ceived by OCD: 0/23/2023 9:57:18 AM U.S. Department of the Interior		Sundry Print Repor
BUREAU OF LAND MANAGEMENT		and the second
Well Name: NV NAVAJO 20	Well Location: T29N / R14W / SEC 20 / NESE / 36.7108734 / -108.3259586	County or Parish/State: SAN JUAN / NM
Well Number: 4	Type of Well: OTHER	Allottee or Tribe Name: SHIPROCK
Lease Number: 14206032200A	Unit or CA Name:	Unit or CA Number:
US Well Number: 3004531056	Well Status: Producing Gas Well	Operator: HILCORP ENERGY COMPANY

Type of Action: Plug and Abandonment Time Sundry Submitted: 11:40

HILCORP ENERGY COMPANY NV NAVAJO 20 4 NOTICE OF INTENT TO PERMANENTLY ABANDON
API #: 3004531056
JOB PROCEDURES
 NMOCD Contact OCD and BLM/Navajo 24 hrs prior to MIRU. Comply with all NMOCD, BLM & Navajo, and HEC safety and BLM/Navajo environmental regulations.

Attachment to notice of Intention to Abandon

Navajo 20 #4

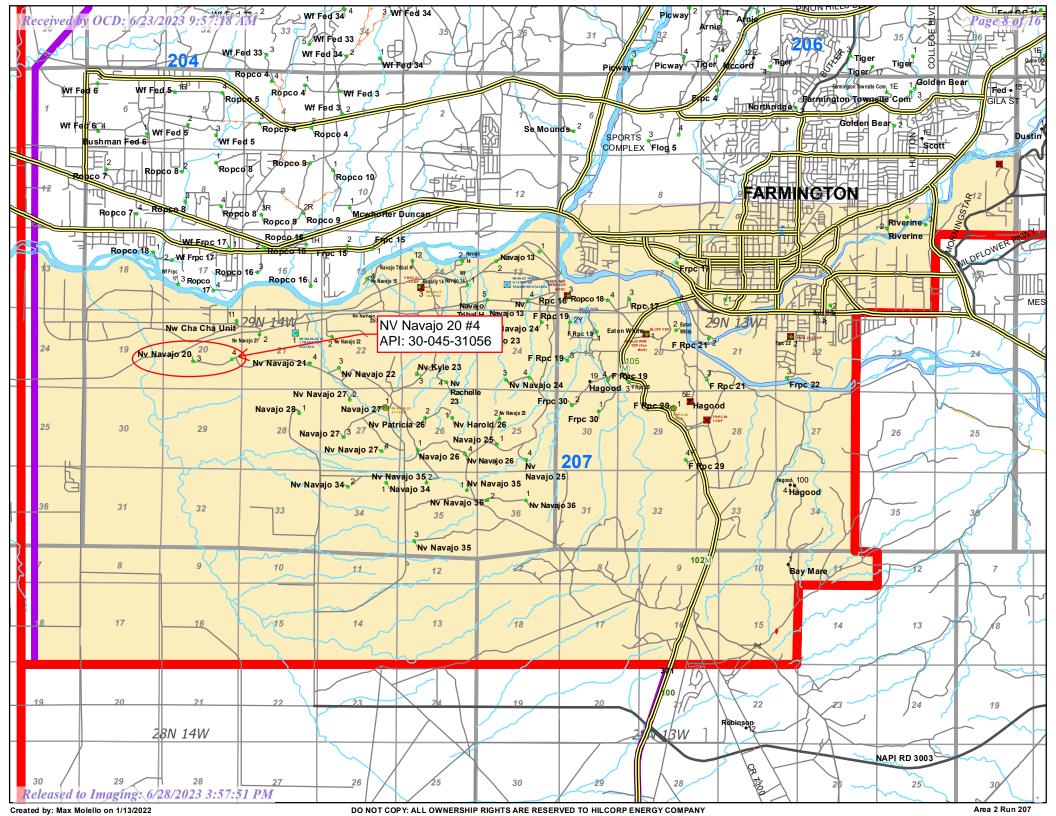
Push fill into cut slope and re-contour with shallow swales and or silt traps for major drainage to create a rolling terrain that matches natural topography drainage features to limit erosion. Legend

All nonnative aggregate will be scraped up and buried in toe of the cut prior to re-contouring.

Navajo 20 #4 Access Road Map

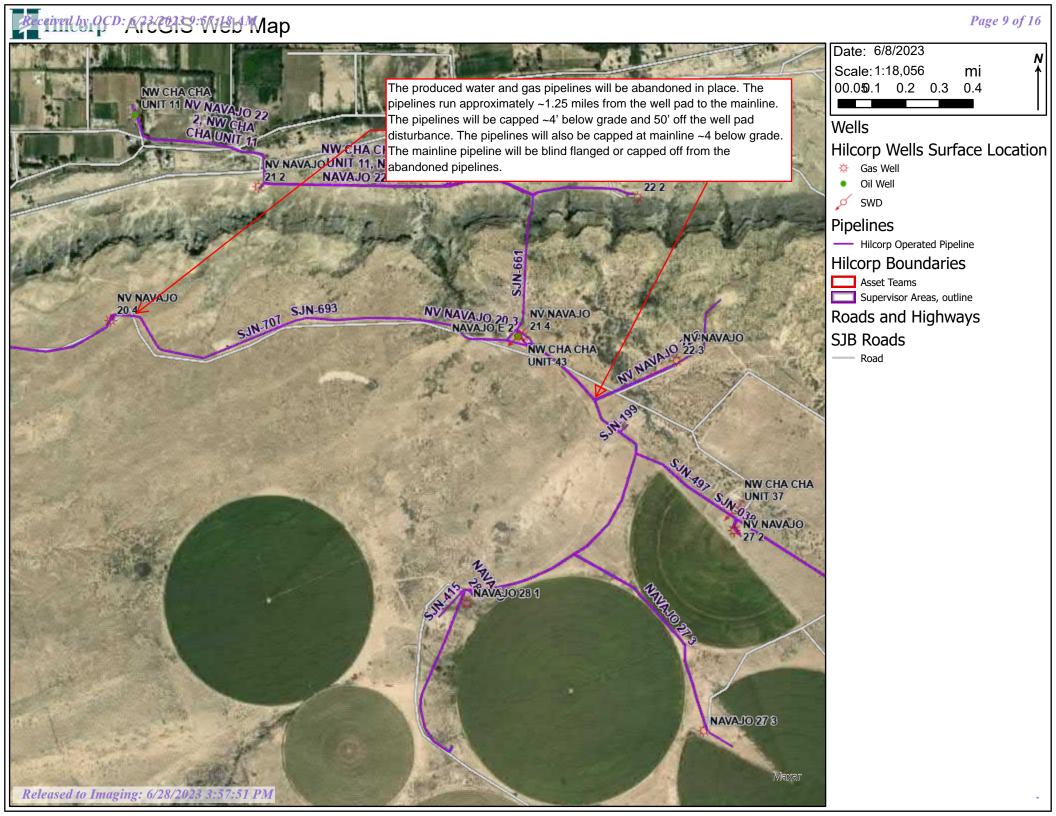
Rip and re-contour ~1 mile of lease access road with shallow swells, berms, and or silt traps as needed to match natural topography drainage features.
